Upgrading the COSINE-100 Experiment for Enhanced Sensitivity to Low-Mass Dark Matter Detection

This file contains all reviewer reports in order by version, followed by all author rebuttals in order by version.

Version 0:

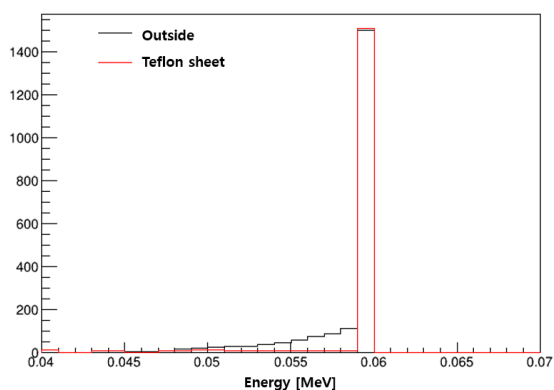
In Figure 8b, there is an asymmetry to the peak shape for the COSINE-100 peak response to the 241Am source. Was that asymmetry characteristic of the detector crystals? Could that be accounted for in the analysis? The improved peak is more symmetric which leads to a better energy resolution. Is this correction understood considering the new configuration?

→ Thank you for raising this important point. The asymmetry observed in the COSINE-100 peak response to the 241Am source is primarily caused by Compton scattering in the encapsulation materials, such as copper.

To investigate this phenomenon, we performed a GEANT4 simulation, generating 241Am gamma-rays both outside the encapsulation and near the Teflon sheet. The results are shown in the figure below. The energy distribution for the Teflon sheet generation exhibits

Figure 1 Activity of alpha event from ^{210}Pb over time.

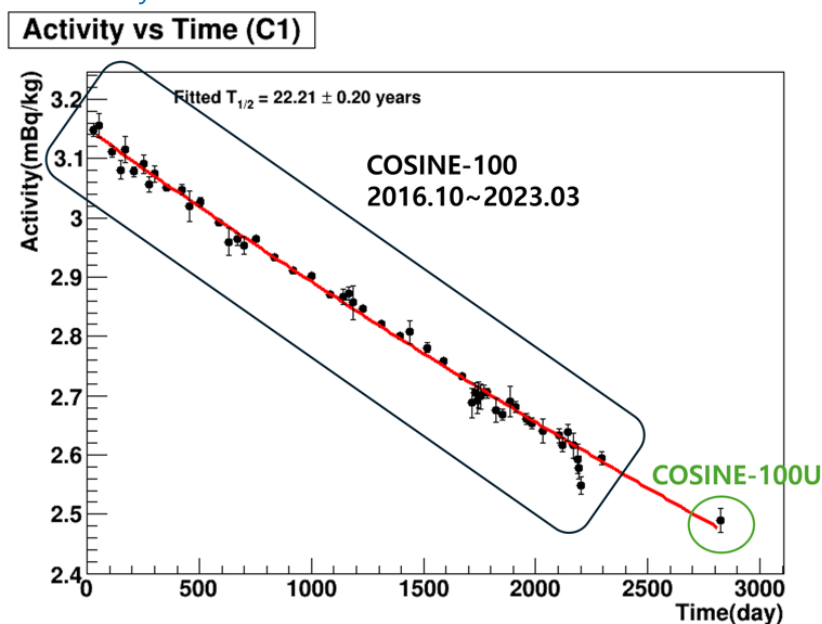
Line 263: Using the data in Table 2, the bulk alpha decreases range from 3.5% to 6.6%. Considering The increases are larger than the stated error, but considering the long 22 year half-life of ^{210}Pb , are these decreases significant? Is there a ‘clear decrease’ as stated?

→ We monitored the bulk alpha rate using six years of COSINE-100 data and additional measurements from COSINE-100U after encapsulation. A plot of the bulk alpha rate of C1 is provided below for reference.

As shown in the plot, the observed decrease in the alpha rate aligns well with the expected decay of ^{210}Pb , consistent with its 22-year half-life. We found all crystals have similar consistency.
